**FINAL DRAINAGE REPORT
FOR
NORTHGATE SUBARU
208 GLENEAGLE GATE VIEW
COLORADO SPRINGS, COLORADO**

FEBRUARY 2025

SF2510 and
PPR2514

EXISTING DRAINAGE MAP

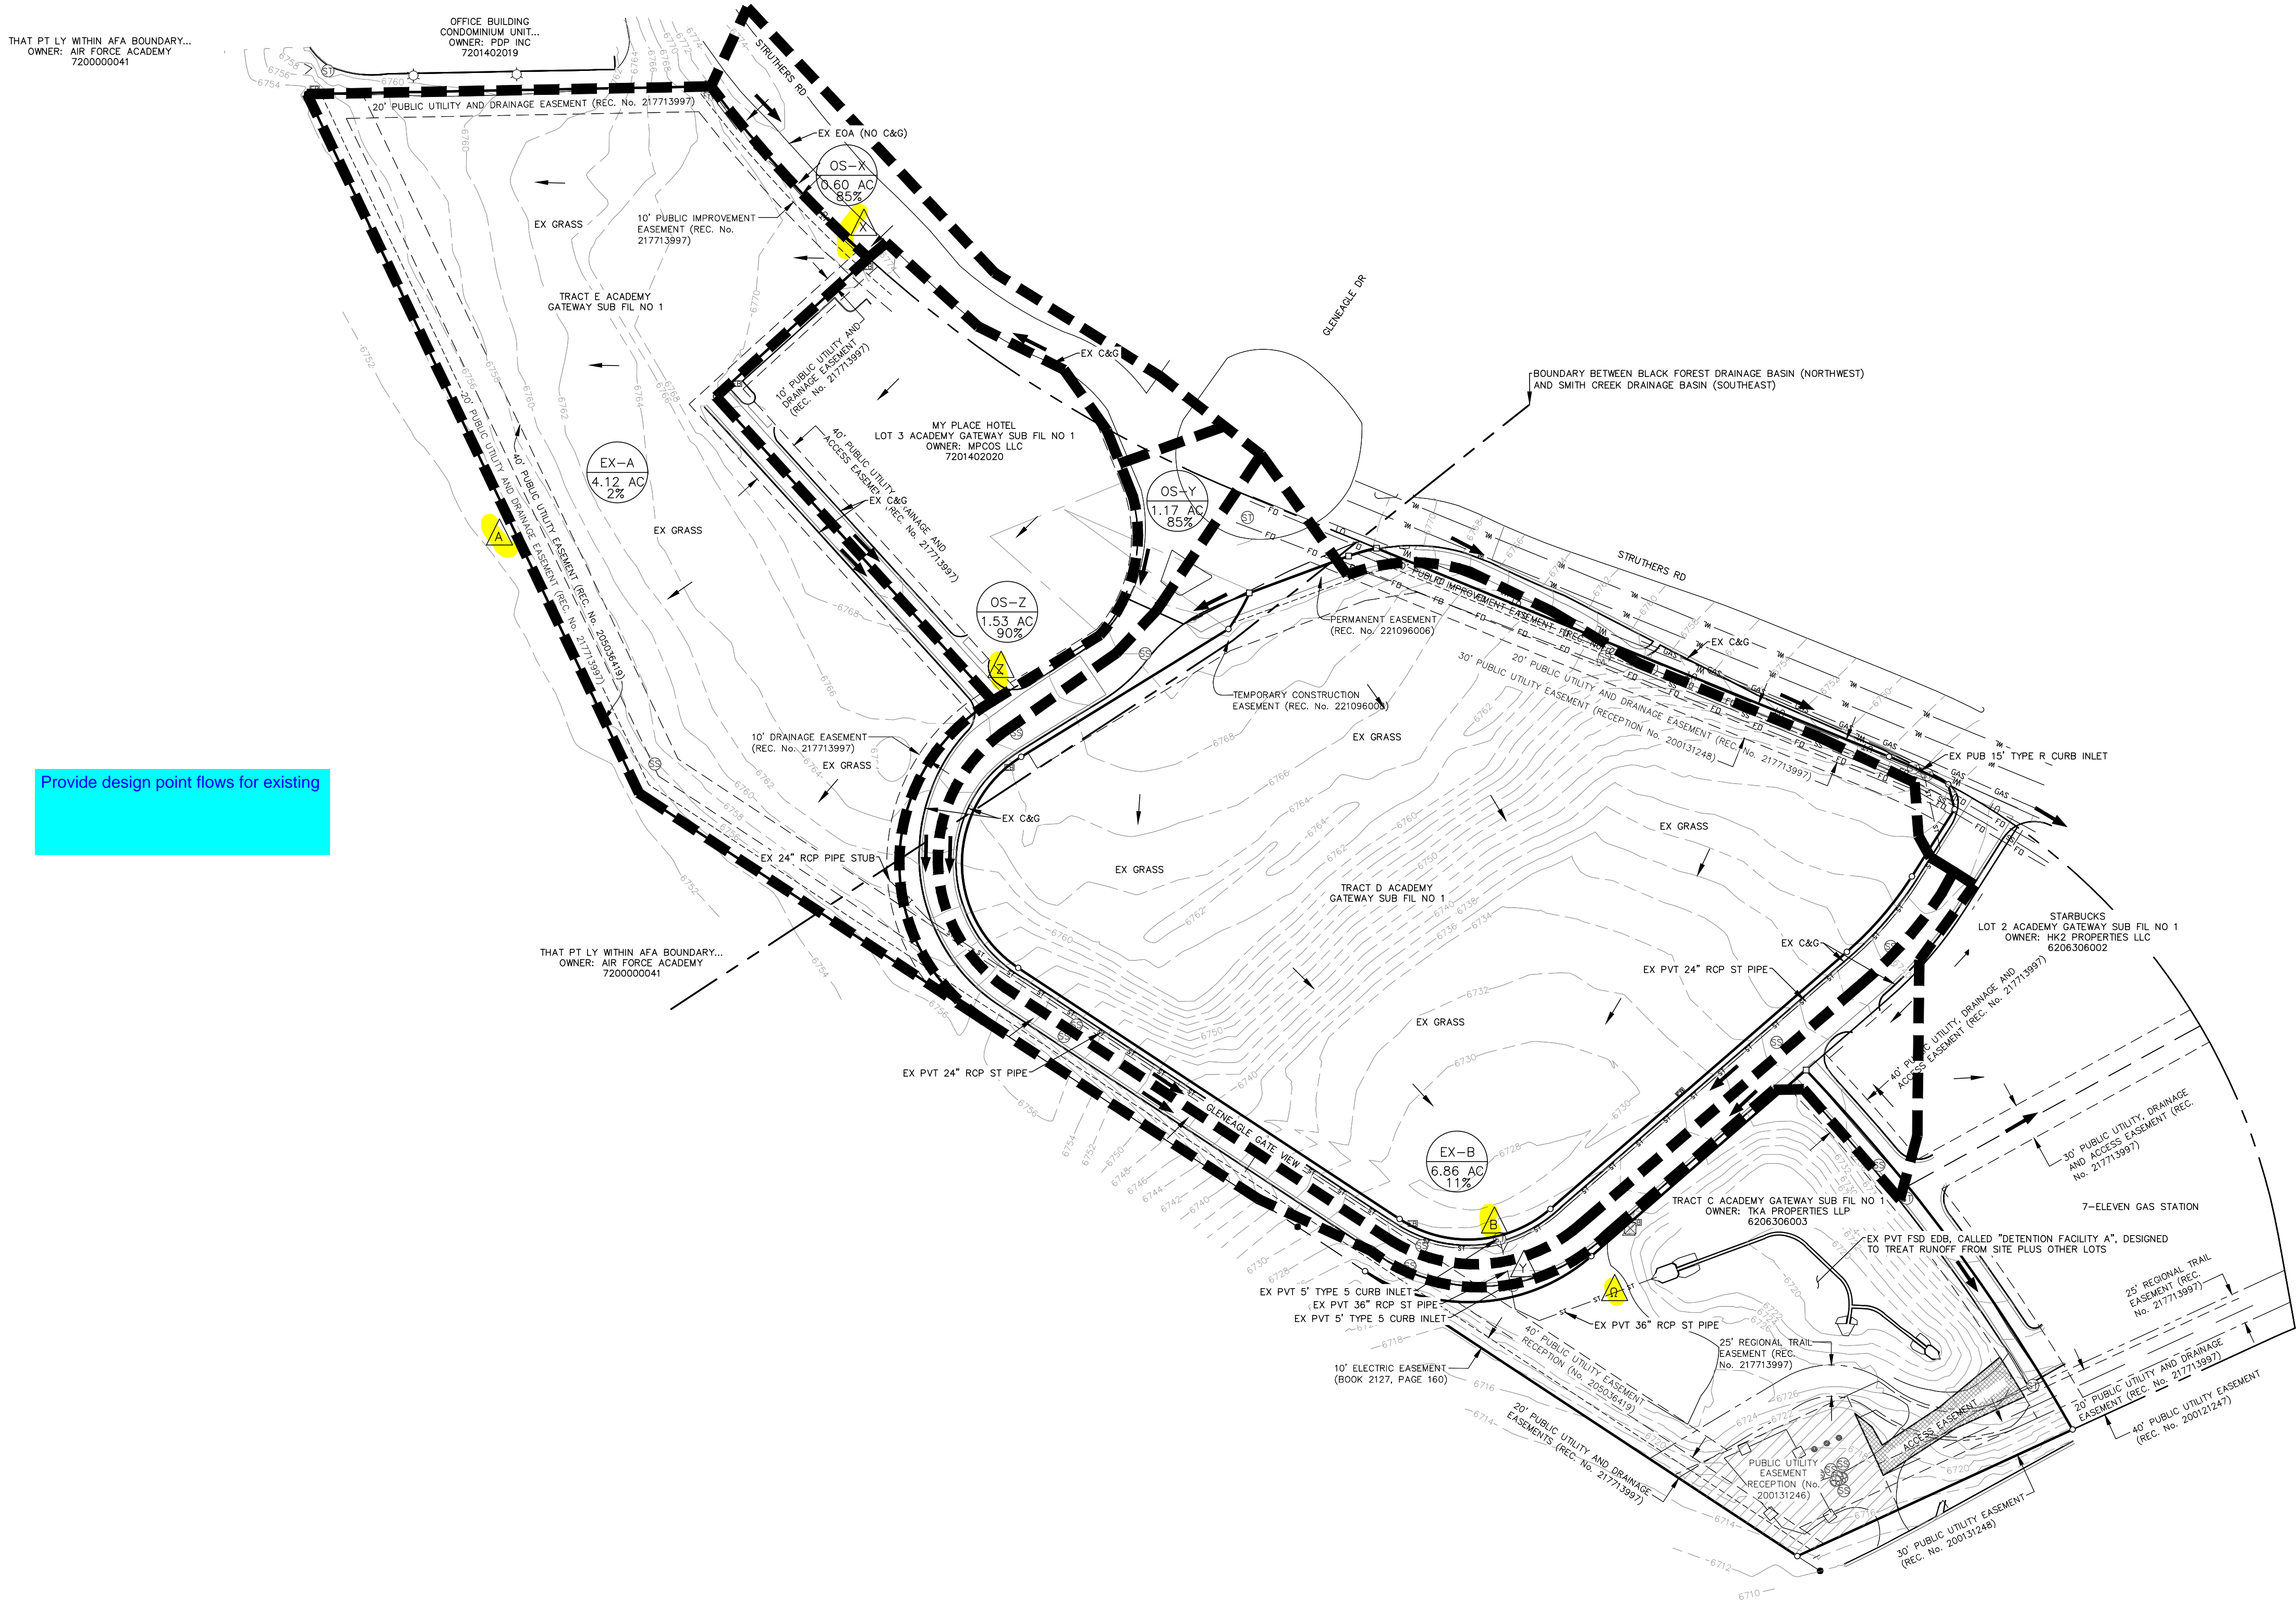
show basin boundaries on the drainage maps for Black Forest and Smith Creek

Provide design point flows for existing

Will need to be updated

TNE Response: It's already there, and even off to the side where it's easy to see.
